Date of Issuance: 10/30/2020	Effective Date: 10/30/2020
Owner: Douglas County	Owner's Contract No.: 15501
Contractor: Resource Development Company	Contractor's Project No.: 18017
Engineer: Keller Associates	Engineer's Project No.: 216030
Project: NVWWTP Improvements	Contract Name: NVWWTP Improvements

Change Order Descriptions

NORTH VALLEY WASTEWATER TREATMENT PLANT IMPROVEMENTS

Pipe to be cut and capped

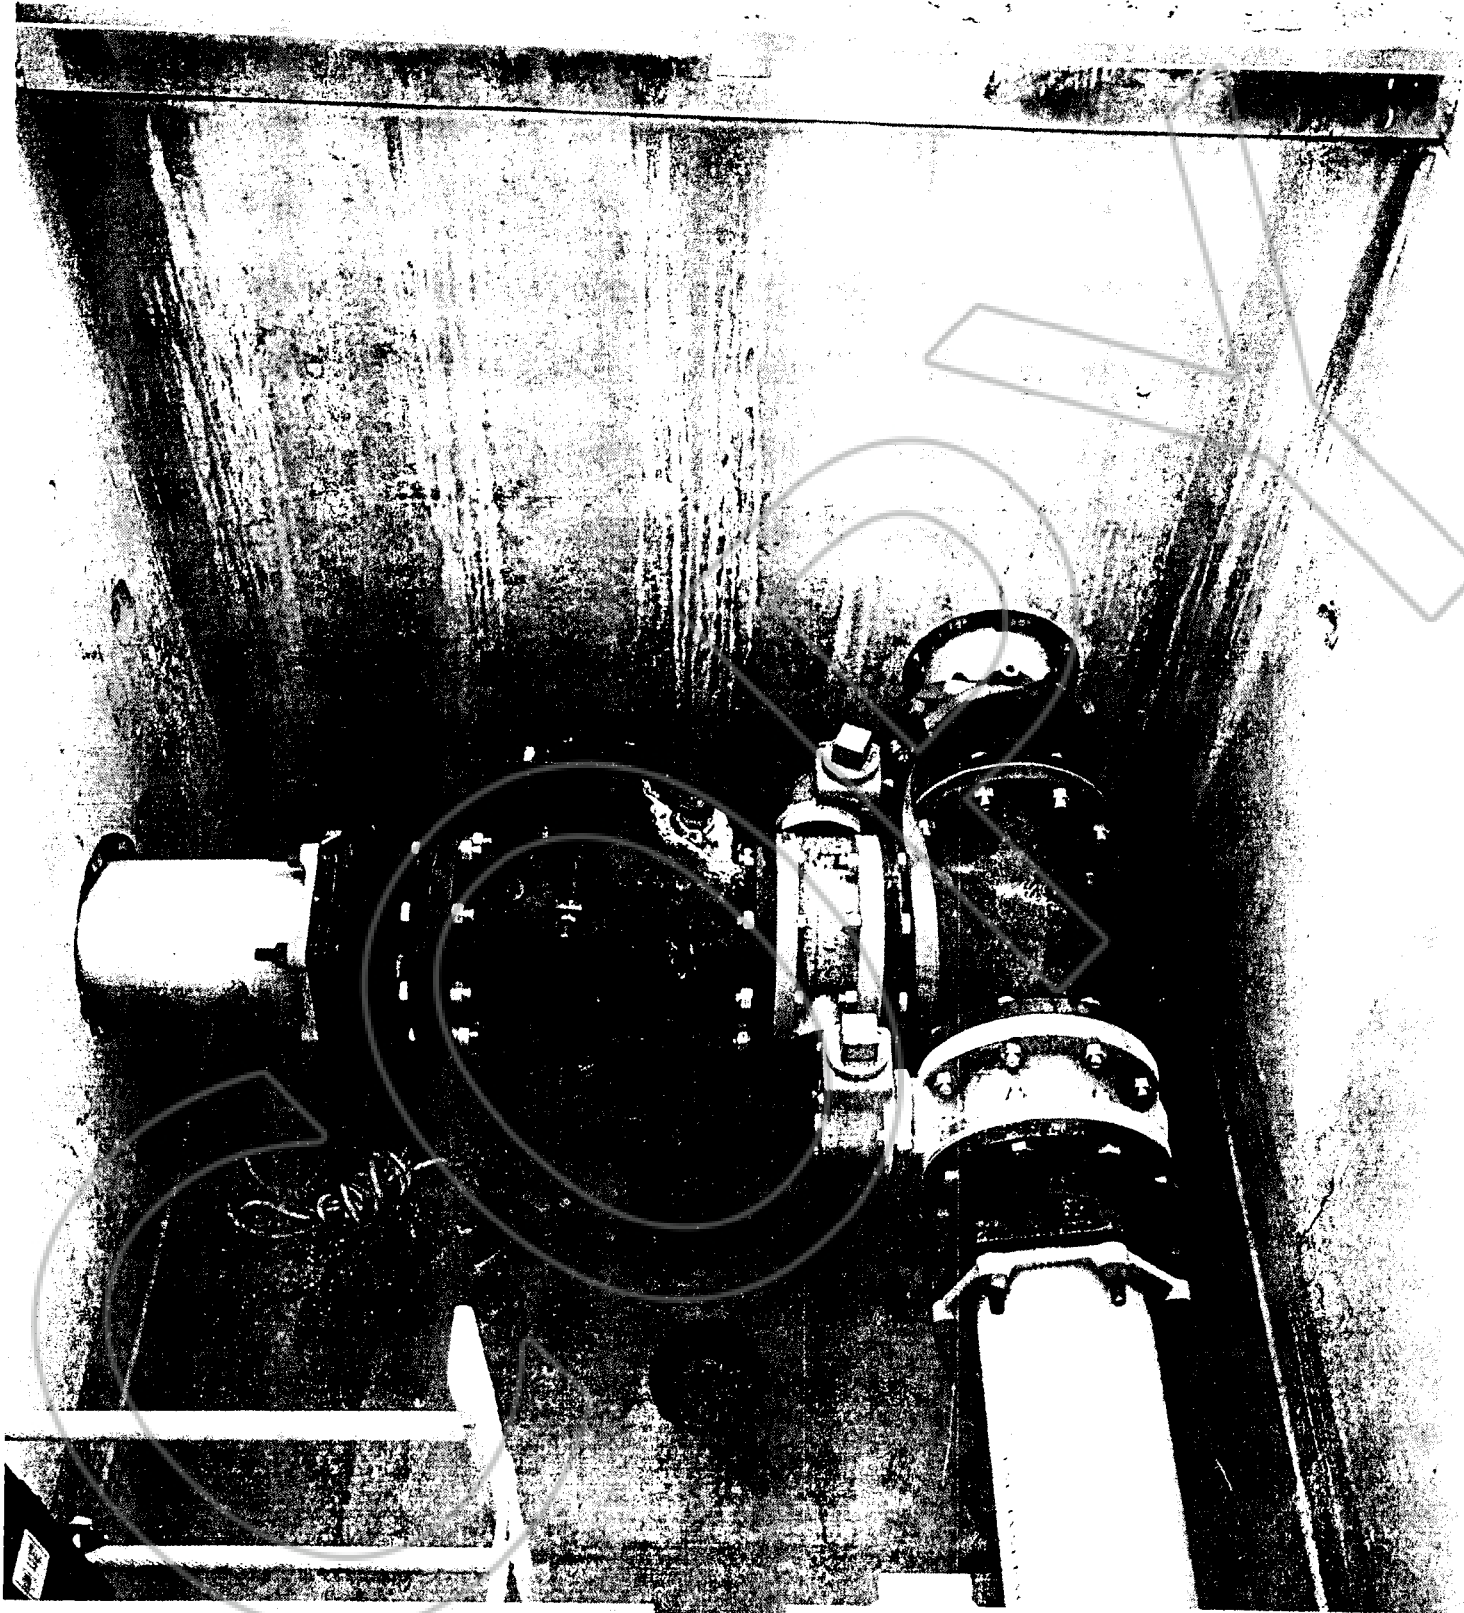
Reason for Change: This WCD covers the labor, materials, equipment, and installation cost to cut and cap the abandoned effluent piping.

Description of change(s): The old effluent pumps have been removed from the operations building. Subsequently the discharge piping was abandoned. However, the discharge piping connects to a live pipeline in a nearby vault after a check valve. Unfortunately, the check valve is no longer functioning which is causing water to flow back into the abandoned pipe. To prevent this, the abandoned pipe will be cut and capped outside of the vault described above and in the picture attached.

It is the engineer’s understanding that the upstream section of pipe is completely abandoned with no planned future uses.
